Public Works (1896) Department.

G.O., No. 13834

Forest Range office —
Oro Revenue Dept regarding
the construction of the — as a
separate building in the compound
of the Taluk office, Communicated
to officers of the P.W.D.

With reference to G.O. No 3021 dated
the 27th ultimo, I have the honor to submit plan
showing two methods of providing the
accommodation required for a Forest range
office in Taluk offices. The approximate cost
of the arrangement as per plan No. 1 will amount
to Rs 1200 and Rs 2500 according to plan No. 2

SECTION ON E. F.

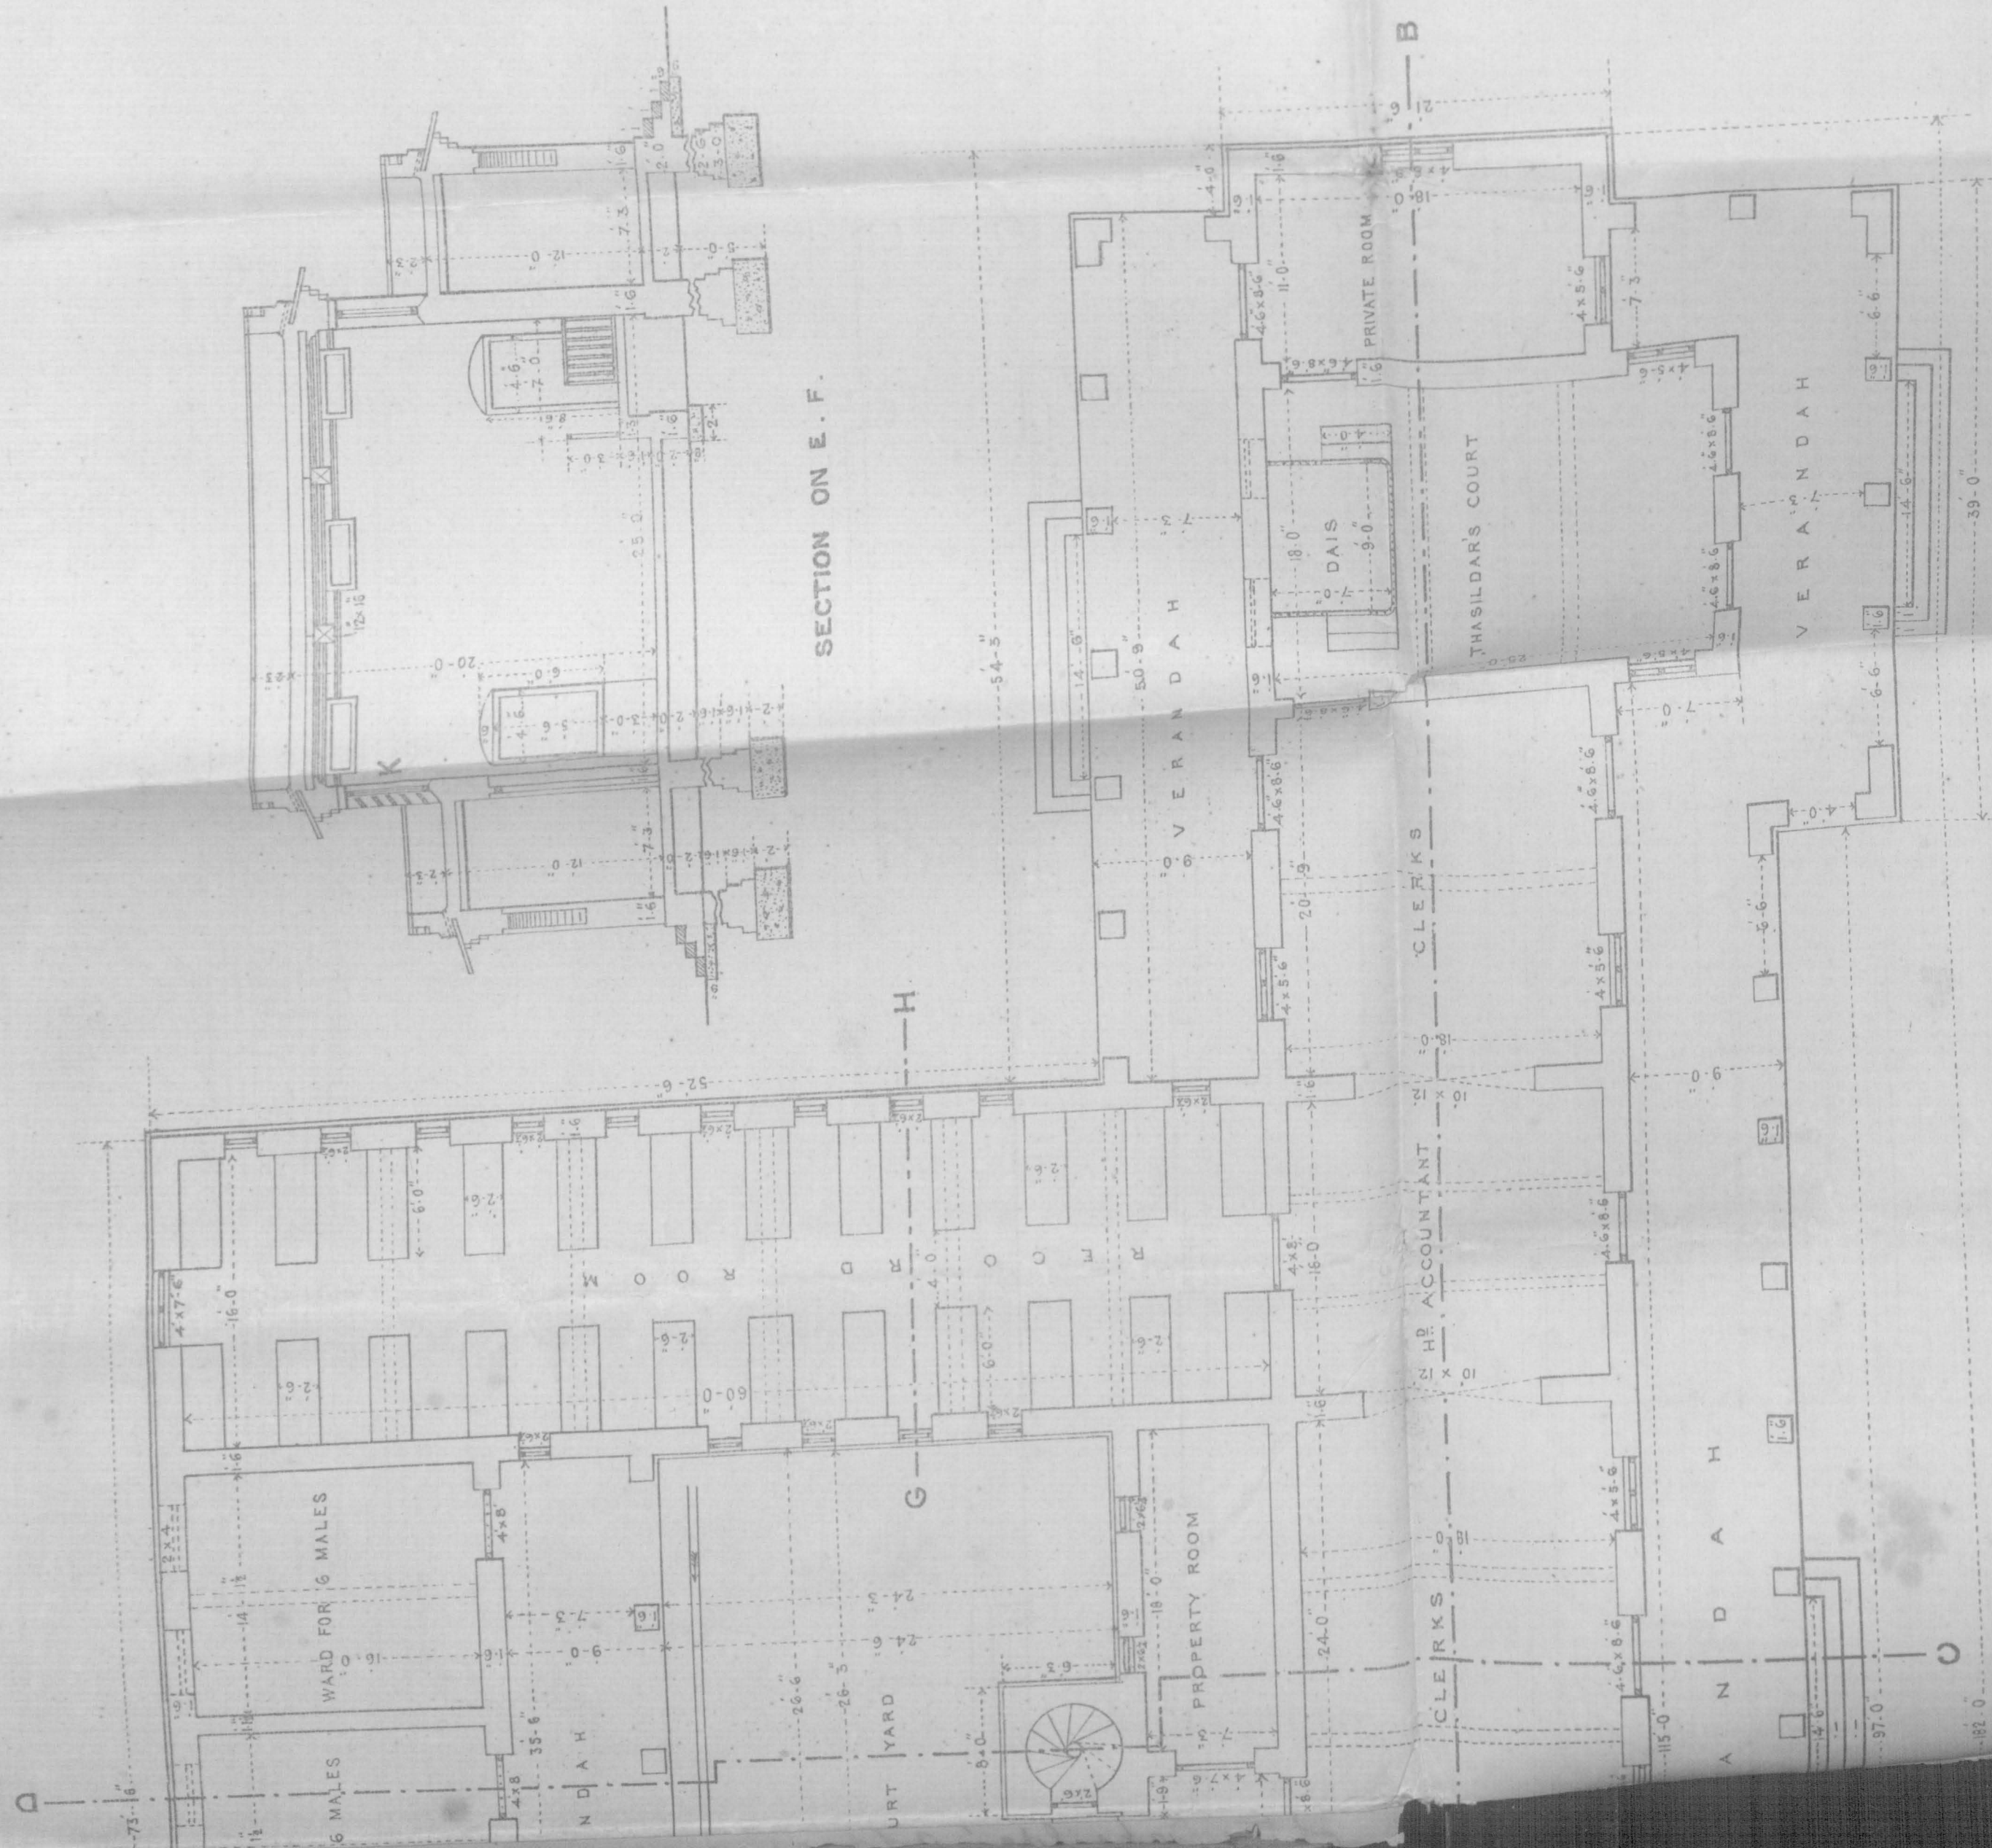
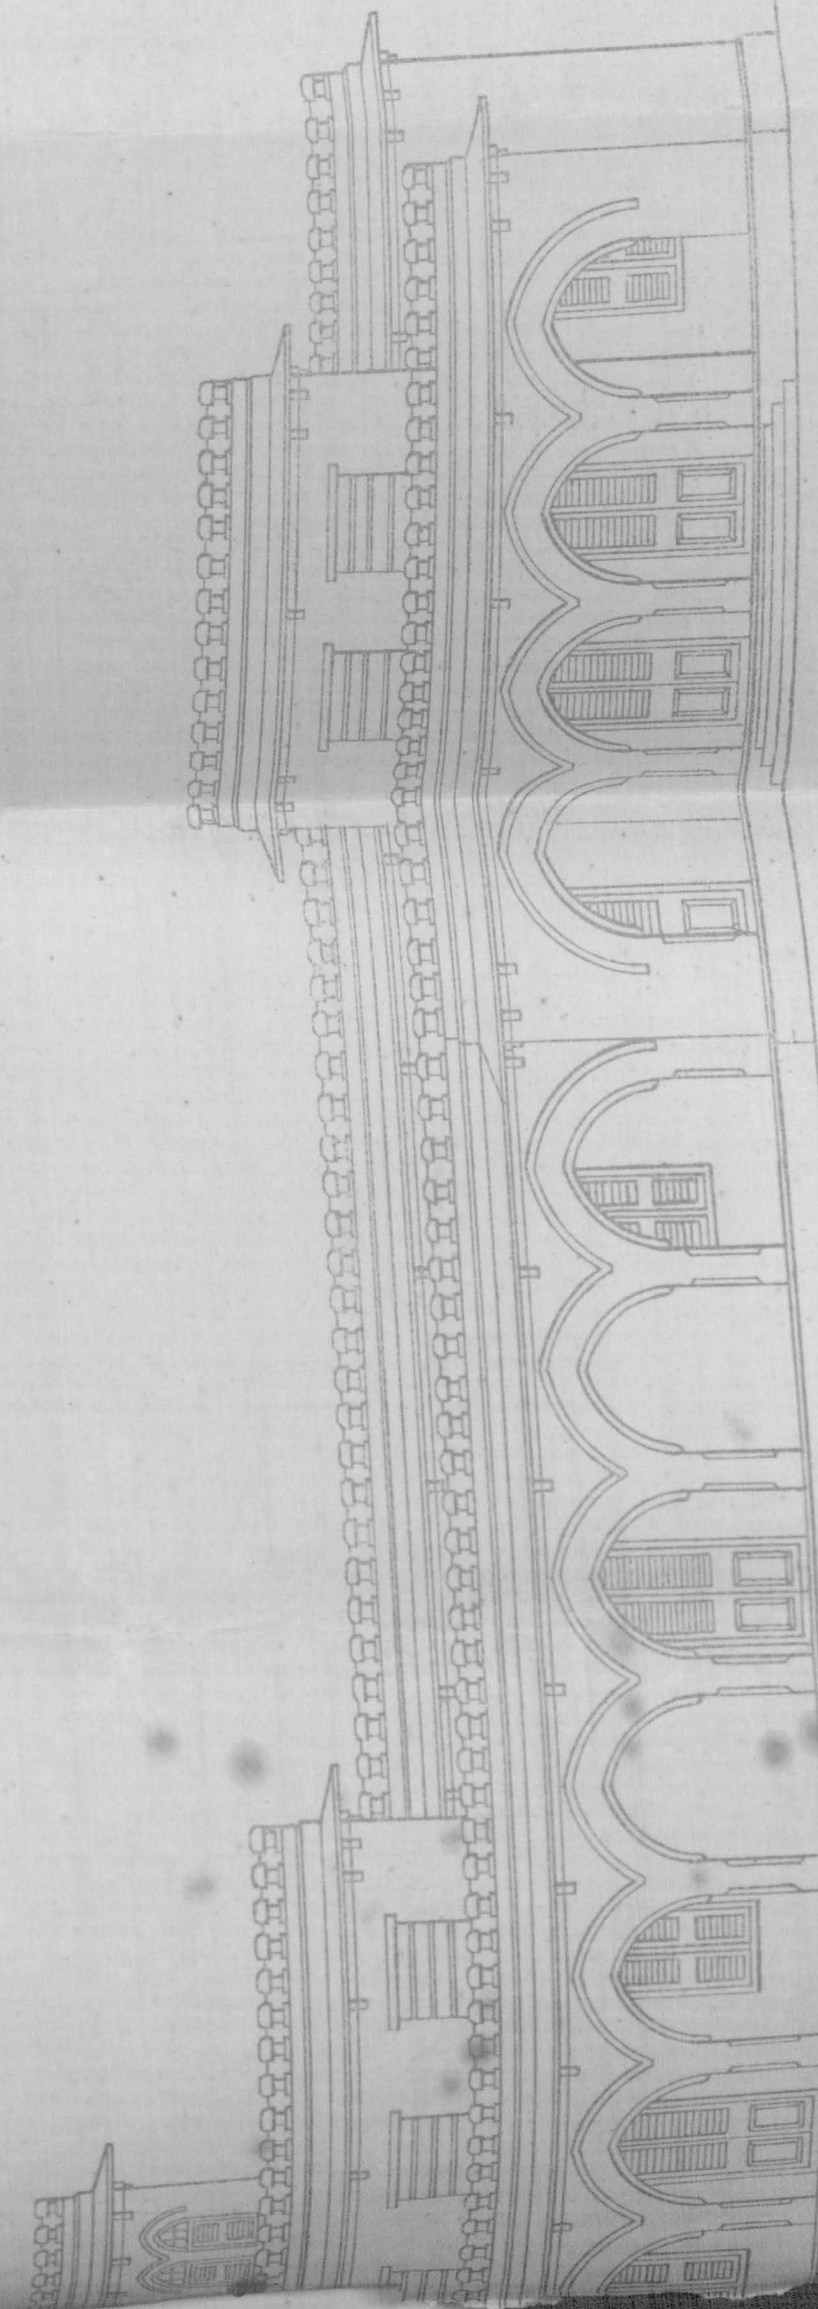
In returning the Enclosures to Board's Proceedings dated 7th February 1896 Forest N^o 187 mis received on the 18th idem I have the honour to state that it appears ^{to be} objectionable that all access from the Taluk office to the Forest Range office should be past the subjail wards and especially that it should be immediately past the doors of the wards for female prisoners. It would be better I think, if it can be arranged that the passage to the Forest Range office should not be in front of these cells.

2 The Cost of the alternate plan of an upstairs building being high, I would suggest that the Forest Range office be built at the end of the subjail wards as proposed in plan N^o I but that the verandah and doors be placed on the left instead of the right of the Forest Range office. Access to the Range office could then be along the back of the subjail wards instead of along the front of them, and if necessary a verandah could run along the

- the back of wards as far as the end of the Arms Room. This would involve 45' of extra verandah, the cost of which is estimated by the Consulting Architect at about Rs 400.
3. If the cost of 45' of extra verandah is considered to be excessive it would possibly not be thought objectionable to build the Range Office along the right side of that part of the Record Room which is lighted from the courtyard on the left, just where the section G-H is marked on the revised type design.

Inspector General of Prisons to whom a reference was made, deprecates the opening of any passage to the Range office past the doors of the gailwards for females and suggests, as an alternative, that the verandah now proposed to be placed to the right of the Range office building, be moved to the left and extended, if necessary, to a length of 45 ft so as to meet the verandah at the back of the Submagistrate's Court. Even this latter plan, the Board considers, is not free from objection, for, instead of the doors, the windows of the wards will still open on the proposed verandah.

3. Mr Cardew also suggests as a second alternative that the Range office rooms might be built along the right side of the record room block just behind the wing where the Tahsildar's Court is situated. But this arrangement will, it is feared, seriously interfere with the light and air in the record room.
4. Taking all these circumstances into consideration, the Board would give up the idea of constructing the Range office as a part of the Taluk Cutcherry.

catcherry building and have it as a separate
building, if possible, in the same Compound,
or, at any rate in the vicinity of the Tahildar's
office. The standard plan for Taluk offices
has been prepared according to the original
requirements and any addition thereto
must tend to spoil the design. Besides,
the proposed Range office consists of
only two small rooms and it will not
cost much to build it separately.
